# Access Compliance Report

## Public Rights-of-Way

### (Pedestrian Signals)

Intersection ID: N/A	Main Street:	Cross Street: N/A	Location: N/A
ADA ID: 4DC14B7D08D4	Signal Type: One Push Button-Non APS	Overall Compliance: No	Severity Score: BTN 1: N/A BTN 2: N/A No BTN: N/A
Codes/Mitigation Info/Possible Solution		Field Measurements/Component Compliance

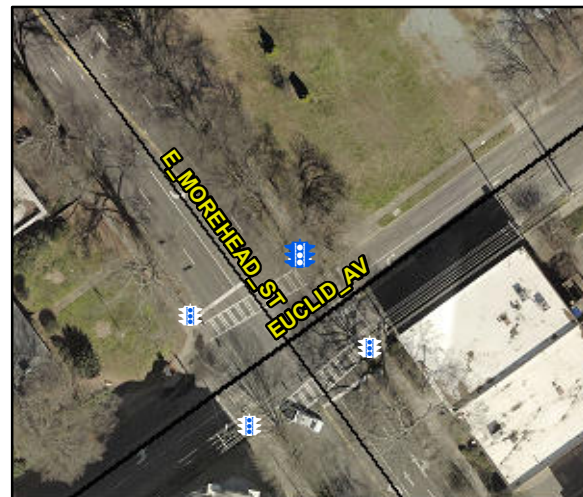
PROW/ADA: R404.3, R404.1, R406.2, R404.7.3

N/A	B 1 FWD Approach Width (in)	N/A	N/A	B 2 FWD Approach Width (in)	N/A
N/A	B 1 FWD Approach Obstruction?	Yes	N/A	B 2 FWD Approach Obstruction?	N/A
N/A	B 1 FWD Approach Obstruction Dist (in)	18.0	N/A	B 2 FWD Approach ObstructionDist (in)	N/A
N/A	B 1 PARA Approach?	Yes	N/A	B 2 PARA Approach?	N/A
N/A	B 1 PARA Approach Constrained?	No	N/A	B 2 PARA Approach Constrained?	N/A
No	B 1 PARA Approach Reach (in)	16.0	N/A	B 2 PARA Approach Reach (in)	N/A
N/A	B 1 PARA Approach Width (in)	N/A	N/A	B 2 PARA Approach Width (in)	N/A
N/A	B 1 PARA Approach Obstruction?	Yes	N/A	B 2 PARA Approach Obstruction?	N/A
N/A	B 1 PARA Approach Obstruction Dist (in)	18.0	N/A	B 2 PARA Approach ObstructionDist (in)	N/A
N/A	B 1 Clear Floor Space Slope (%)	0.6	N/A	B 2 Clear Floor Space Slope (%)	N/A
N/A	B 1 Clear Floor Space XSlope (%)	10.5	N/A	B 2 Clear Floor Space XSlope (%)	N/A
N/A	B 1 PAR Slope (%)	0.3	N/A	B 2 PAR Slope (%)	N/A
Yes	B 1 Height (in)	38.0	N/A	B 2 Height (in)	N/A

Possible Solutions: Provide PAR As Indicated. Provide Push Button Extension. Provide Clear Space.
